**Notice of Public Hearing to Consider)
Technical Status and Proposed Revisions)
to On-Board Diagnostic System)
Requirements for Heavy-Duty Engines,)
Passenger Cars, Light-Duty Trucks,)
Medium-Duty Vehicles and Engines)**

**Hearing Date: August 23, 2012
Agenda Item 12-5-2**

**COMMENTS OF THE
TRUCK AND ENGINE MANUFACTURERS ASSOCIATION**

August 20, 2012

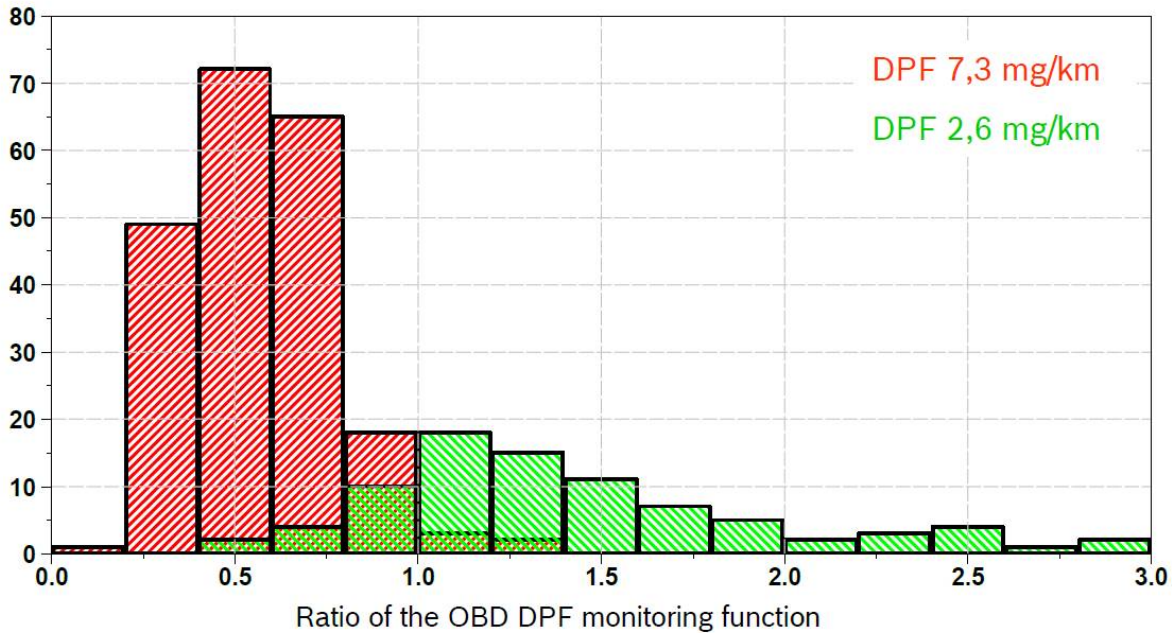
The common way to monitor the filter performance today is by using a delta pressure sensor measuring the pressure difference over the filter. At some point it will be hard to distinguish between a malfunctioning filter and a fault free filter due to part tolerances, sensor tolerances, aging, driving conditions and different application installations.

There are today sensor suppliers developing sensors for PM measurements in HD vehicles but the technology is new and the sensors are at a prototype stage (see below discussion on PM sensor considerations). It is important for the engine manufacturers to continue evaluating available technology. The current technology has sensor-to-sensor variability as well as run-to-run variability that is too high for a robust filter performance monitor.

Figure 1: Effect of NOx Sensor accuracy on conversion efficiency determination at 2013 threshold of +0.2 g/bhp-hr.

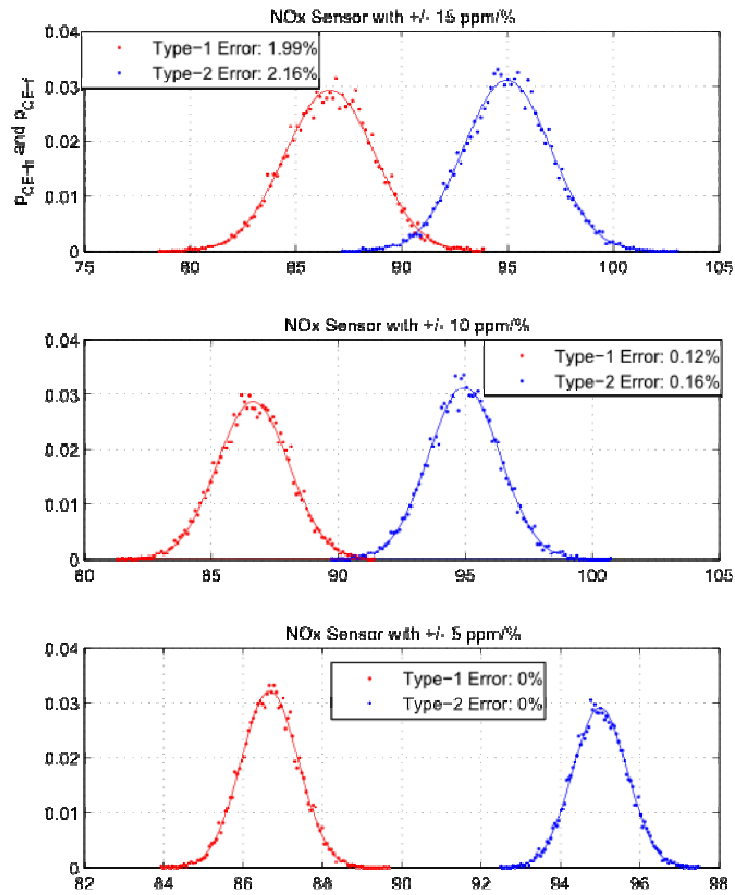
The accuracy of the NO_x sensors has a significant impact on the ability to accurately measure conversion efficiency of the SCR Catalyst. Experiments have been run to measure the probabilities that NO_x sensors with varying degrees of accuracies would lead to both the correct determination of a healthy system and the correct determination of a failed system. Figure 1 demonstrates the probability that the proper decision regarding conversion efficiency is made given the proposed 2013 HD OBD Threshold of +0.2 g/bhp-hr

In the graphs, a Type-1 error is an error associated with improperly classifying a healthy part as being failed, and a Type-2 error is an error associated with improperly classifying a failed part as healthy. The top plot of Figure 1 shows that with NOx sensors with a manufacturer specified tolerance of ± 15 ppm from 0-100ppm and $\pm 15\%$ from 100-1500ppm, the resulting NOx conversion efficiencies of healthy- and failed-systems lead to error rates of 1.99% for Type-1 errors and 2.16 % for Type-2 errors. The center plot of Figure 1 demonstrates that sensors with an accuracy of roughly ± 10 ppm from 0-100ppm and $\pm 10\%$ from 100-1500ppm improves separation but it still yields to error rates of 0.12% for Type-1 errors and 0.16% for Type-2 errors. Only when the NOx sensor technology can yield to the accuracy levels of ± 5 ppm from 0-100ppm and $\pm 5\%$ from 100-1500ppm, can separation be achieved with 0.00% for Type-1 errors and 0.00 % for Type-2 errors when only considering the error of the sensor.

Figure 2: Effect of NOx Sensor accuracy on conversion efficiency determination at 2013 threshold of +0.4 g/bhp-hr.

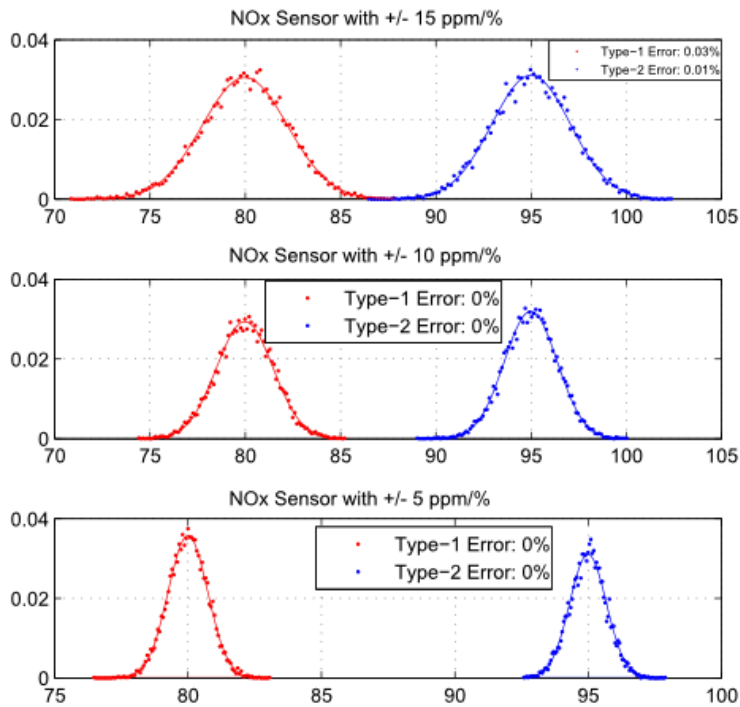
Figure 2 demonstrates the impact of NOx sensor accuracies on conversion efficiency determination when a threshold of +0.4 g/bhp-hr is considered. At this threshold it can be seen in the middle graph that the sensor error is not significant enough to cause a misclassification of the part based on a conversion efficiency calculation.

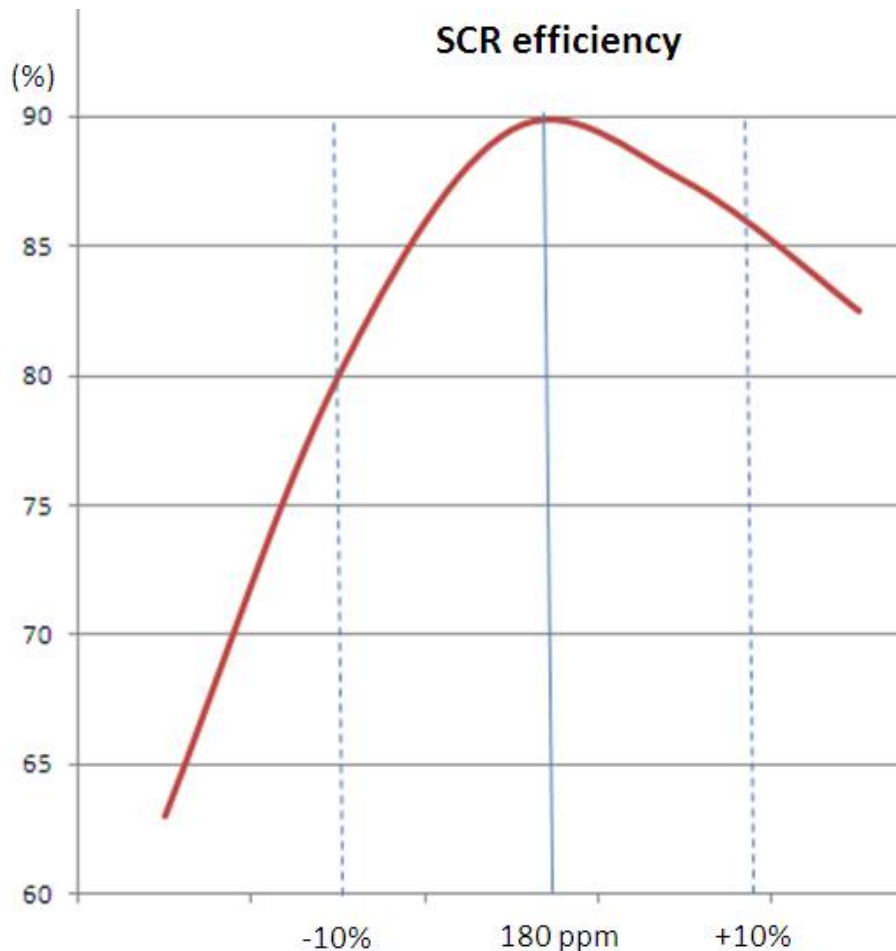
The intent of the NOx sensor threshold monitor should be to identify NOx emissions exceeding a certain level as accurately as possible. Because of only small differences between the NOx sensor (typically referred to as "generation 2.0") available for 2010MY and the NOx sensor "generation 2.5" for 2013MY, and the current 2013MY threshold level, too many false detections are likely to result. False MILs will lead to unnecessary and unjustified "repairs" and costs, including warranty costs. ARB should revise the 2013 MY threshold requirement to maintain the existing 2010MY threshold for 2013MY.

The NOx sensor was introduced for HD vehicles some years ago. While the sensor technology has matured and the reliability of the sensors has increased, the already challenging 2010MY requirements are today hard to manage with the existing NOx sensor. The next generation sensor (generation 2.5) is only marginally better for 2013MY.

Figure 1 - Tolerance compensation feature

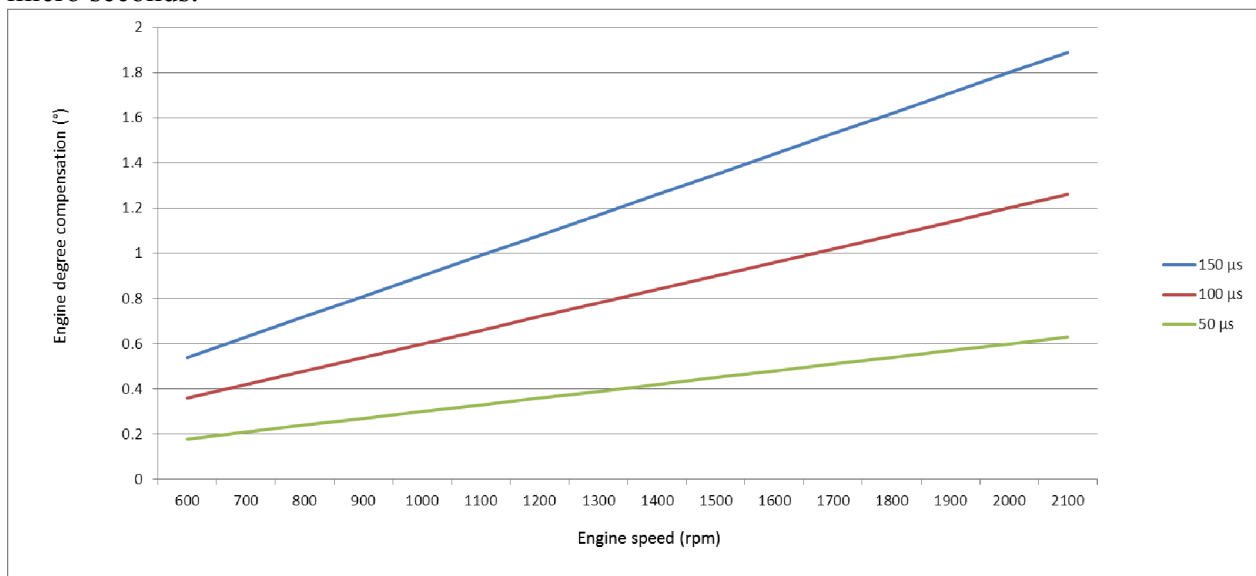
For a six-cylinder diesel engine each cylinder represents 120° of the flywheel during two revolutions. Compensations made in microseconds for one injector will then result in an increase or decrease of the FIE-related parameters such as timing. The graph below shows how a certain number of microseconds will impact the timing for compensations made with 150, 100 and 50 micro seconds.

The x axis presents the engine speed and the y axis presents the crank angle compensation made for the tolerance compensation.

Figure 2 - Normal injector distribution

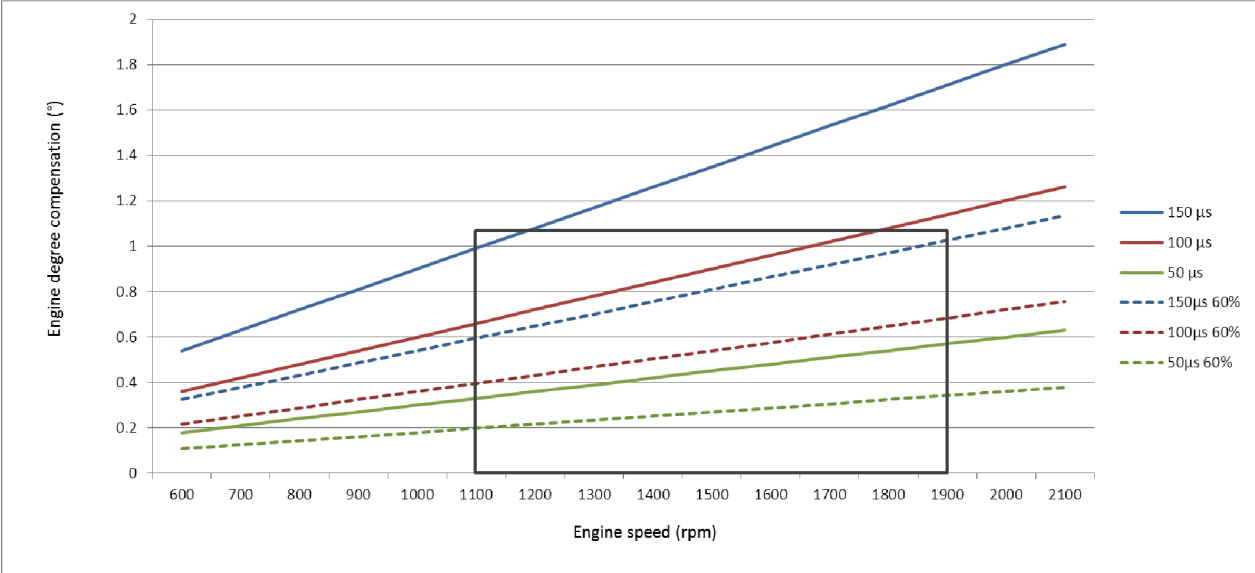
A normal distribution of the injectors used in production in 99% of the cases is less than 60% of the total possible amount of the compensation. Taking that as well as the normal operation window into account results in the figure below. The compensation will then be close to or less than one crank angle degree for one injector. This is a significant low adjustment compared to the monitoring levels for detecting pressure, timing and quantity related faults.
